PARTS & SERVICE NEWS

REF NO.	AT03144A
DATE	Oct. 20, 2003
(C)	Page 1 of 4

SUBJECT: MODIFICATION TO REPAIR LAMP SWITCH HARNESS ON HD465/605-7

PURPOSE: To introduce modification procedure to repair the lamp switch harness on HD465-7 and HD605-7 dump trucks

1-2. Revised places:

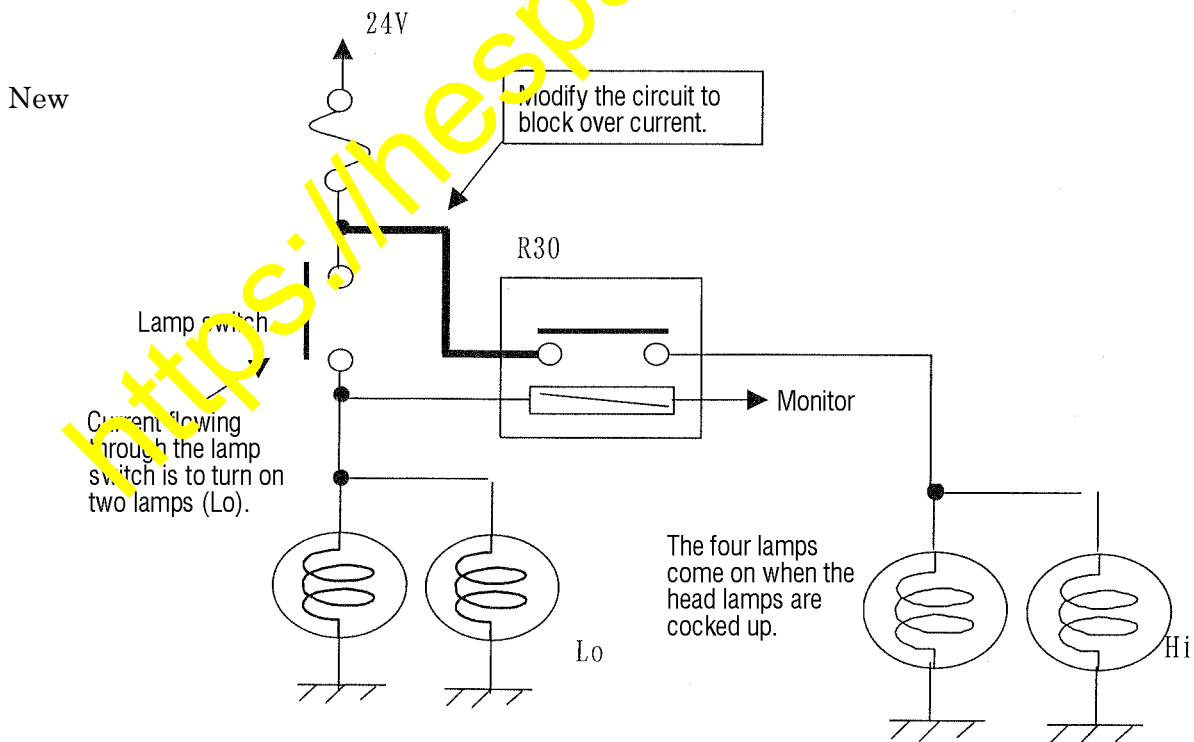
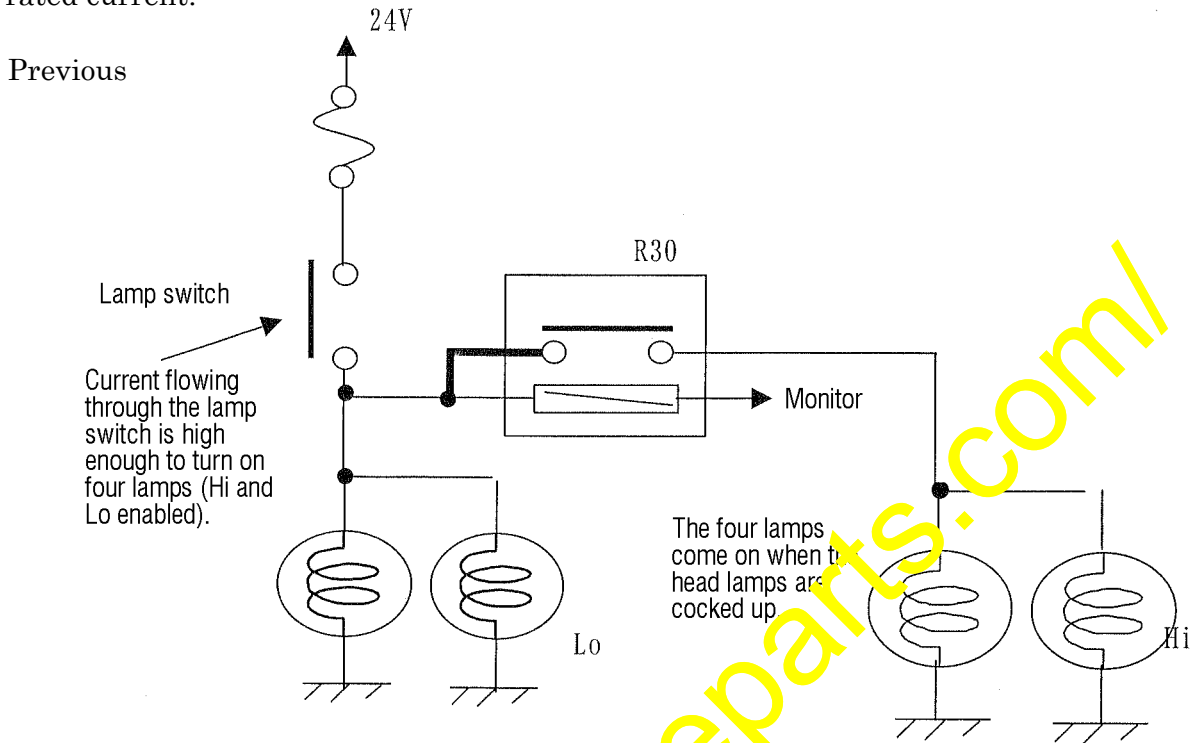
Since there is a possibility of occurrence of pre-usage failure of the lamp switch by overcurrent flowing through the lamp switch in the lamp switch circuit when the head lamps of the HD465-7 and HD605-7 dump trucks are cocked up (four lamps) resulting in failure of lighting of the lamps on these vehicles, make the modification being introduced in this Service News to repair the lamp switch circuit harness.

The harness circuit for the lamp switch passing current has been changed from four lamps (Hi, Lo) to two lamps (Lo), and the passing current has been reduced below the rated current.

10 places 	Oct. 20, 2003	Addition of application serial Nos. and correction of error in writing.
---	---------------	---

Connecting sections of the connectors of the R30 relay

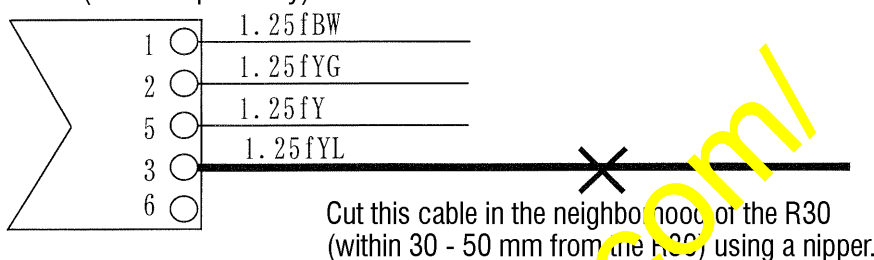
The wiring harnesses in the neighborhood of the relays R29 and R30 being positioned inside the operator's cabin are to be modified so that the current flowing through the light switch may be limited to a level less than the rated current value. (Refer to Fig. 1 and 2 on the next page.)

Procedure 2)

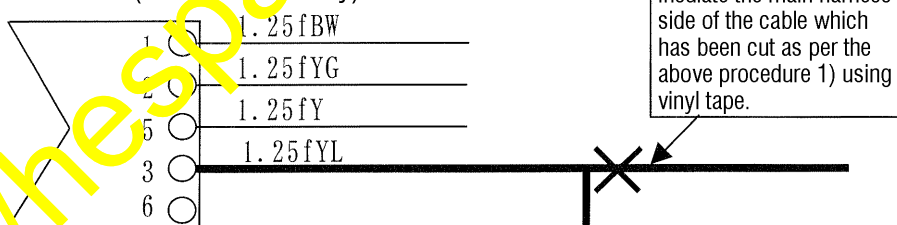
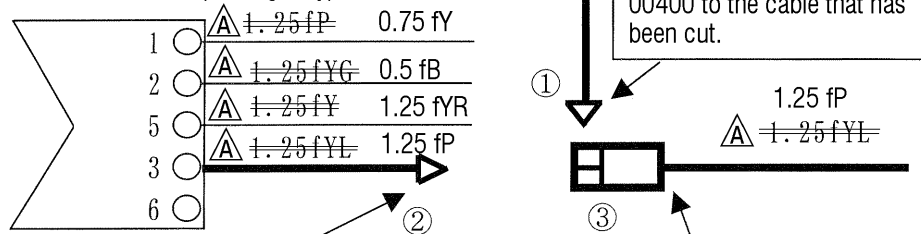
Connect the connector 08021-00400 to the R29 side cable of the cable which has been cut as per the above procedure 1).

Connect the connector 08022-04003 to the main harness side of the cable which has been cut as per the above procedure 1).
